January 31, 2014

Re: Stormwater Permit Response  
Bulk Sampling Activity

This letter serves to transmit to your office responses to comments dated December 20, 2013.

BULK SAMPING PROJCT  
 ACCESS ROAD 6  
 WETLAND AREA DETAIL NEAR STA. 17+00

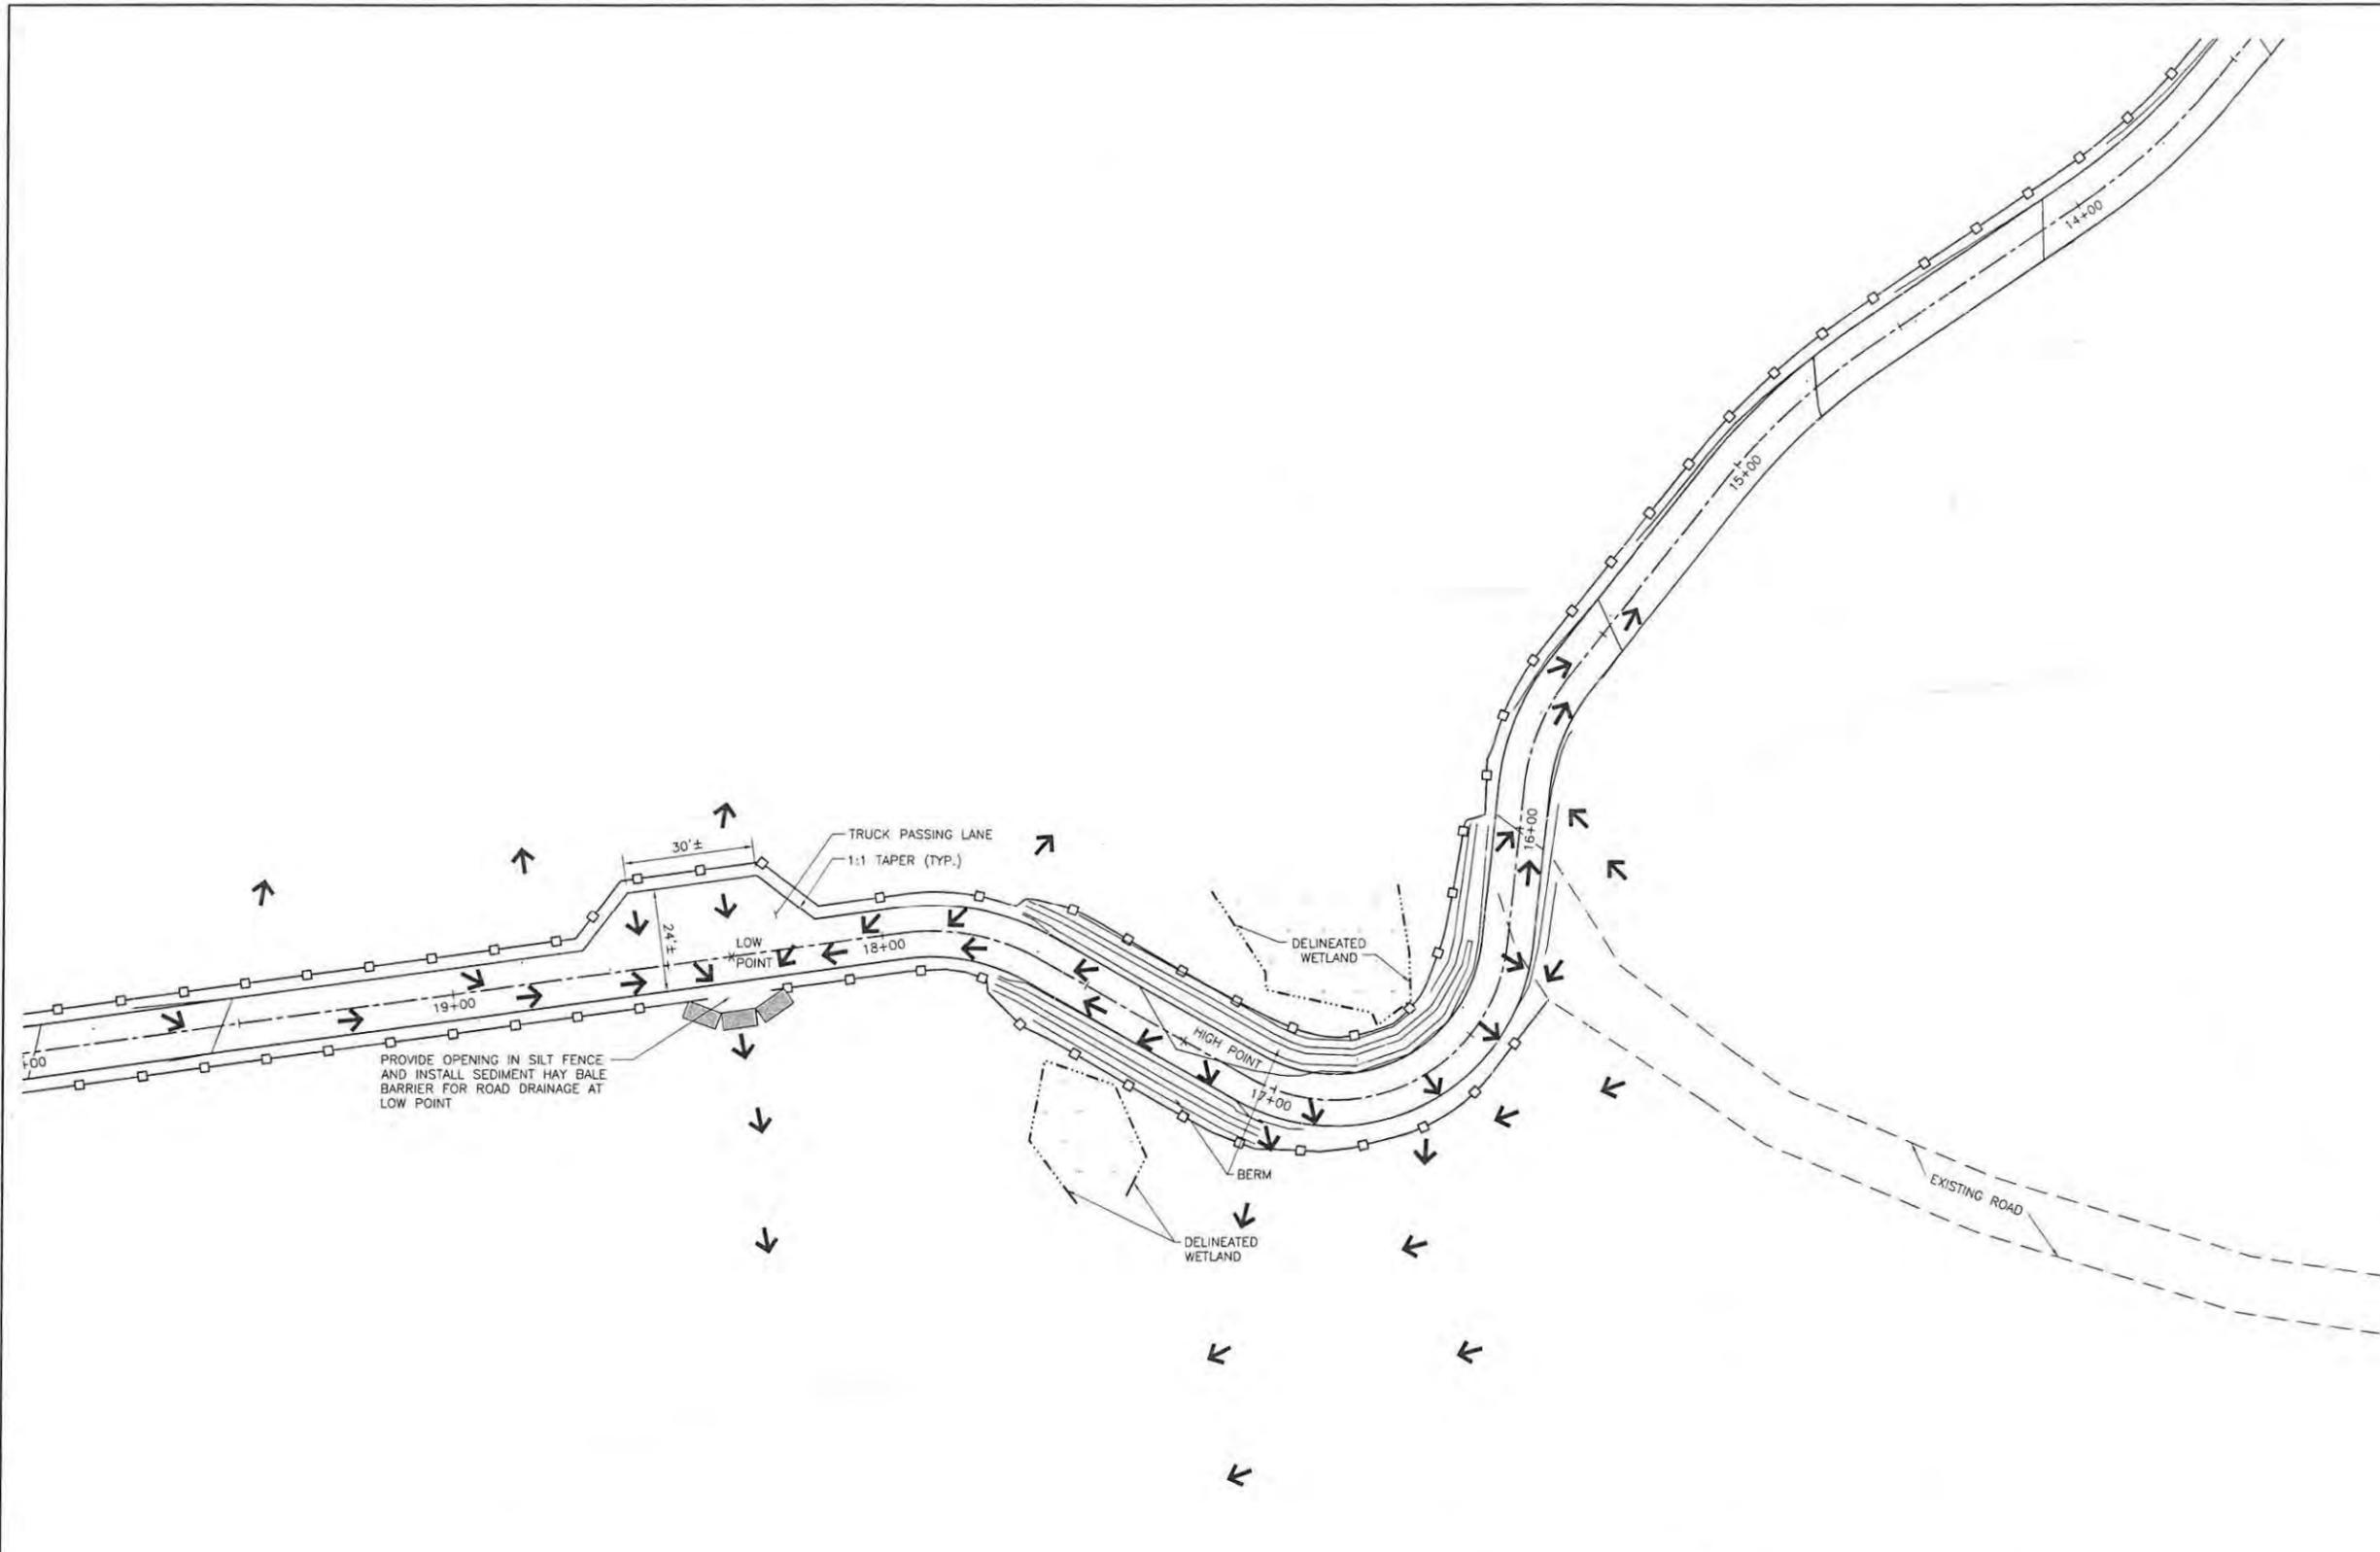
8. Please provide a better detail of what is proposed for station 16+00 to 18+00. Specifically, it is unclear where water goes around the wetlands in this location. Further, on the south, left going uphill, it appears that the water will be directed all the way down the slope from 23+50 to around Station 17+00. Due to the proximity of the wetlands in this location, please verify whether the outfall from the silt fence will impact wetlands. I have essentially the same comment for the north side of the road except it has an even longer flowpath. I would advise a break in the silt fence at around station 18+50 to 19+00. A discharge in this location appears to completely miss wetlands and bleeds off some of your stormwater.

11. Please provide a detail of the Truck Passing Lane.

**RESPONSE: The area near Stations 16+00 to 18+00 has been provided in more detail on Sheet C010. The road grade has been modified to indicate that the road will drain away from the high point at Station 17+25. Surface runoff will exit the system through a hay bale dike at Station 18+50 and/or through the silt fence material.**

**RESPONSE:** The truck passing lane consists of widening the road surface to two lanes (approximately 24 feet wide) to allow approaching traffic to allow opposing traffic to pass. A detail of the truck passing lane is provided within Sheet C010.

**BULK SAMPLING PROJECT**  
 ACCESS ROAD 3 & 6  
 TYPICAL ROAD SECTIONS

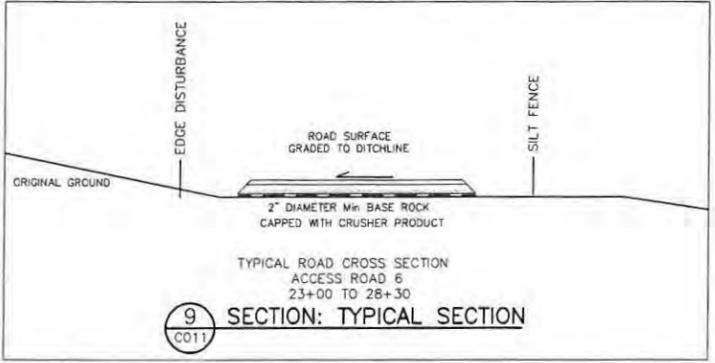
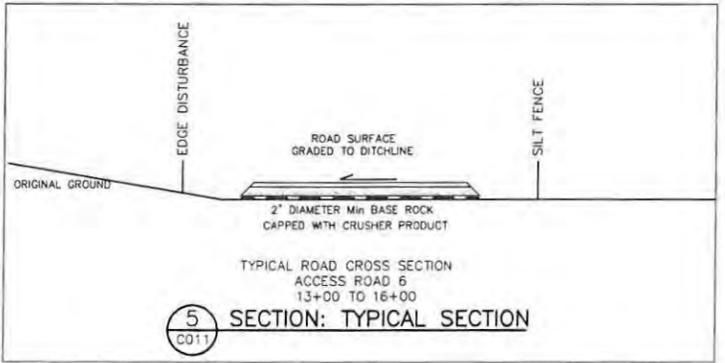
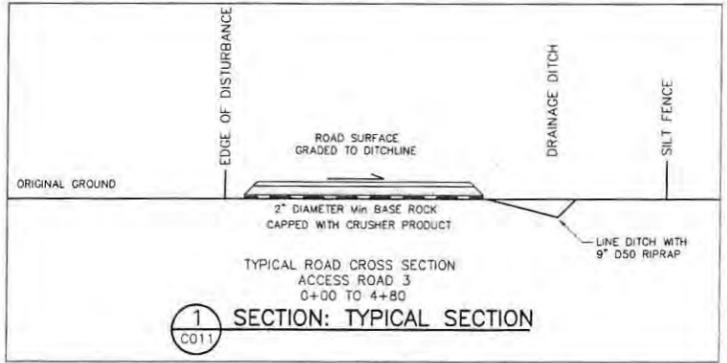
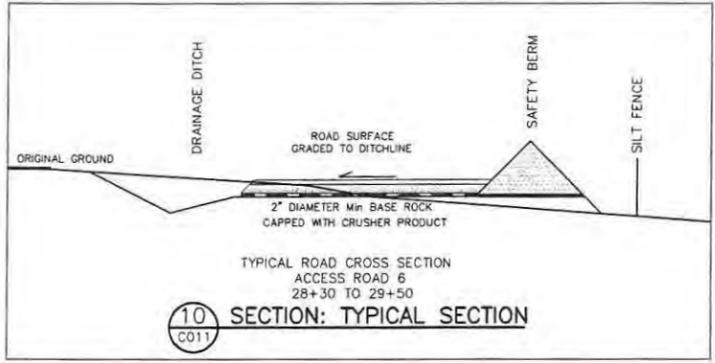
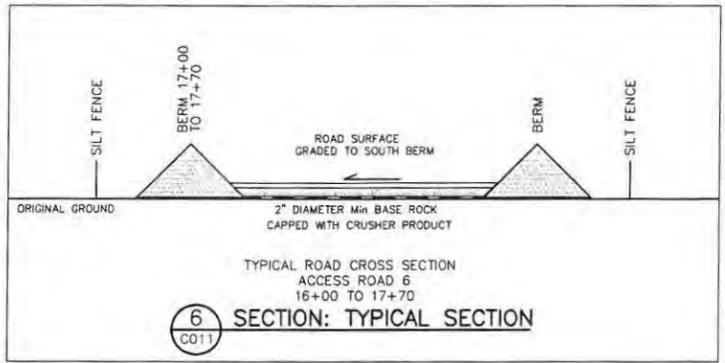
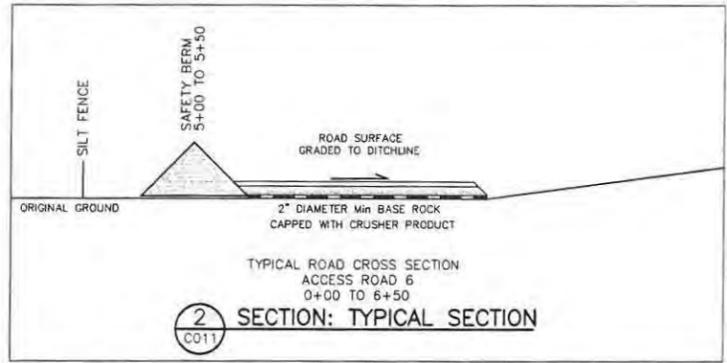
9. I am also trying to square Detail 4 with the reality that you will likely have to cut on the uphill side of the roadway and fill on the downhill side; if only to have a good place to lay down your roadbed. This may mean that your roadway footprint is considerably larger than 12 feet +/- (toe of slope will need to extend out a ways on downhill *side*). It further means that restoration will be a bit more involved than the simple removal of gravel and geotextile material. It also prevents an erosion control challenge when you are taking water across the road and down a longer, steeper, unvegetated slope. Please indicate areas of cut and fill on your plan set. Are you able to calculate fill slopes, how far the toe of slope extends and whether additional BMPs are warranted? It would seem that this information would allow you to determine where and whether culverts are a reasonable option.

**RESPONSE: Typical cross sections for different portions of the roads are provided as Sheet C011. The cross sections were chosen to illustrate the varying conditions along the proposed construction.**

**The plan proposes an approximate 12 feet wide road. In addition, there will be additional widths needed for berms and ditches and the installation of erosion control structures.**

**The road has been located to provide a minimal amount of cut and fill activities. Design considerations have included items such as following the existing ground surface contours to the extent possible and using existing roads whenever possible.**

**BULK SAMPLING PROJECT**  
 BULK SAMPLE SITE 1  
 EROSION AND SEDIMENT CONTROL PLAN

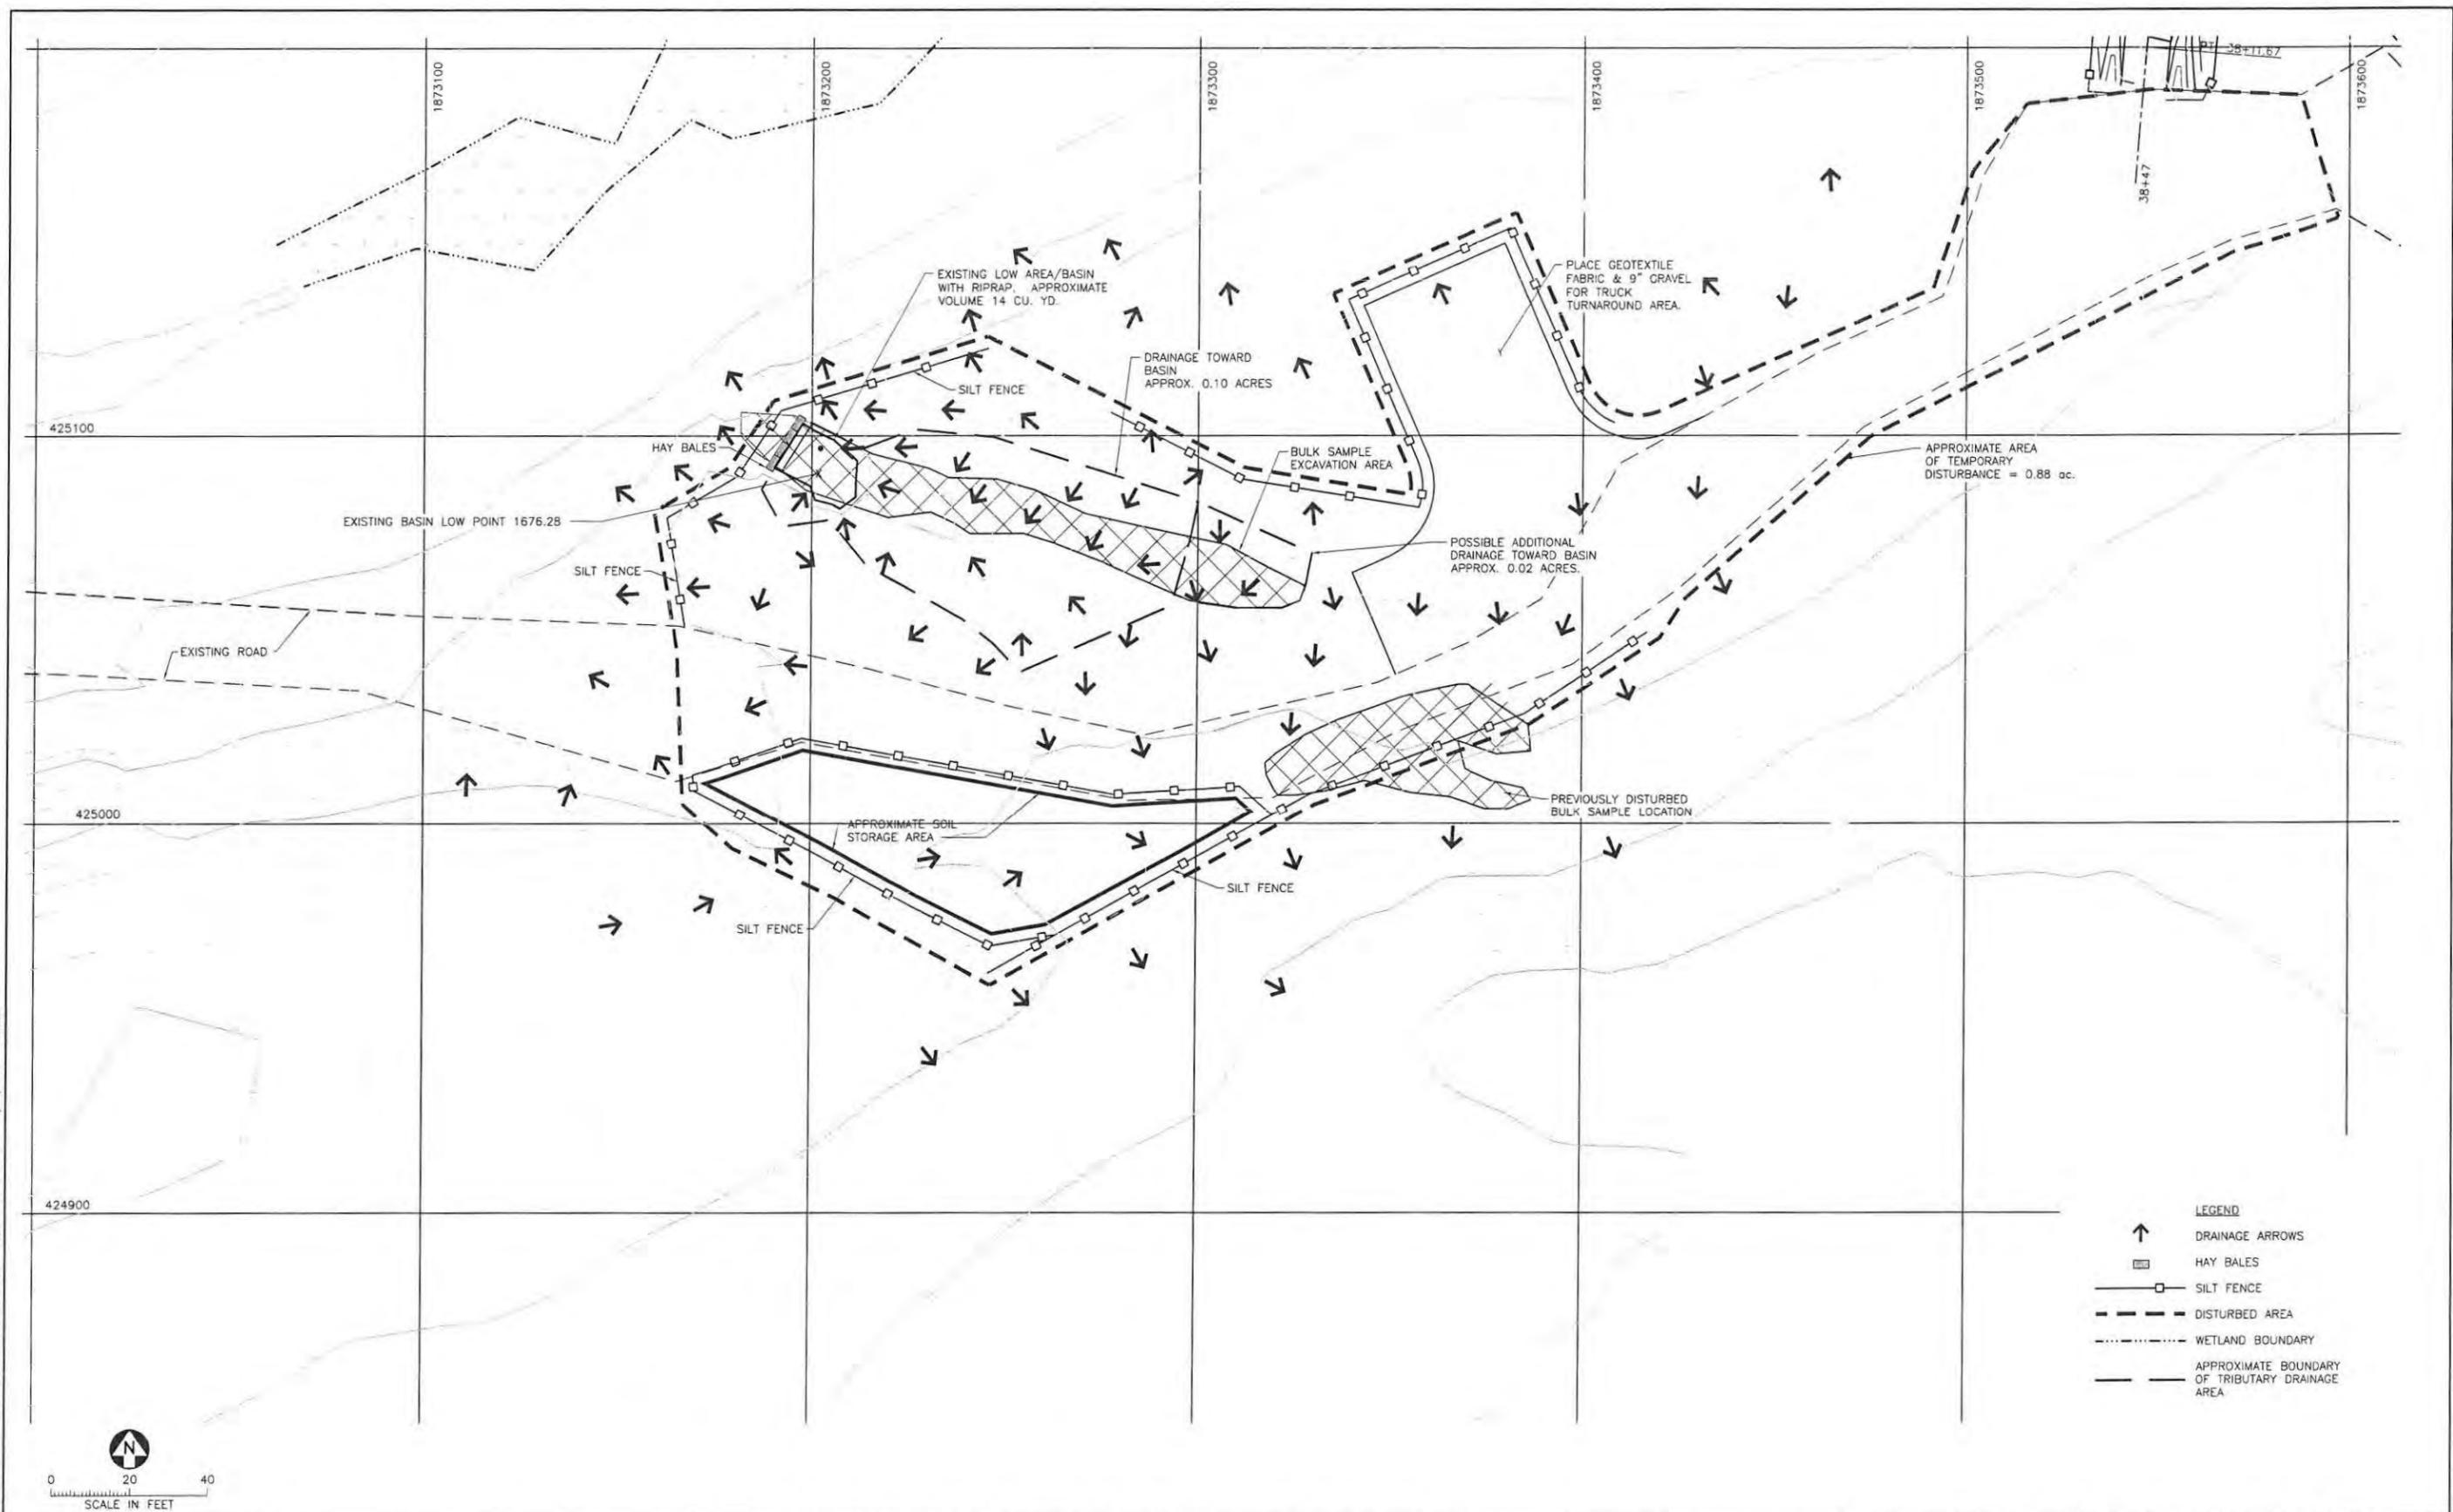
13. Please use the Sedimentation Basin Technical Standard rather than the hay bales with sump detail proposed for BSI.

14. Due to the proximity of the wetland north of BSI, you are advised to develop contingencies to install additional erosion controls if those implemented are insufficient to control sediment.

**RESPONSE:** The Sedimentation Basin Technical Standard is designed for drainage areas of 5 to 100 acres. The total disturbed area including roads for Bulk Sample Site 1 is 0.88 acres. The drainage area reporting to the north end of the Bulk Sample Site consists of 0.12 acres with a peak runoff of 0.66 cubic feet per second based on a 10 year 24 hour storm event. The Peak Runoff from a 2 year 24 hour storm is 0.39 cubic feet per second. The natural depression and the hay bale dike will contain this flow.

The Technical Standard #1062 for a drainage area of less than 1 acre suggests the use of ditch checks. The drainage area of the bulk sample excavation is 0.12 acres. This drainage design provides the use of a hay bale dike plus a natural depression measured at 378 cubic feet which exceeds the requirements of Technical Standard #1062.

**RESPONSE:** In the event that the provided sediment control is not adequate to control runoff from Bulk Sample Site 1, lines of silt fence will be installed between the wetland areas and the project area to trap sediment before it would enter the wetlands.

It should be noted that Bulk Sample Site 1 is provided with more than the required sediment control found in the stormwater program.
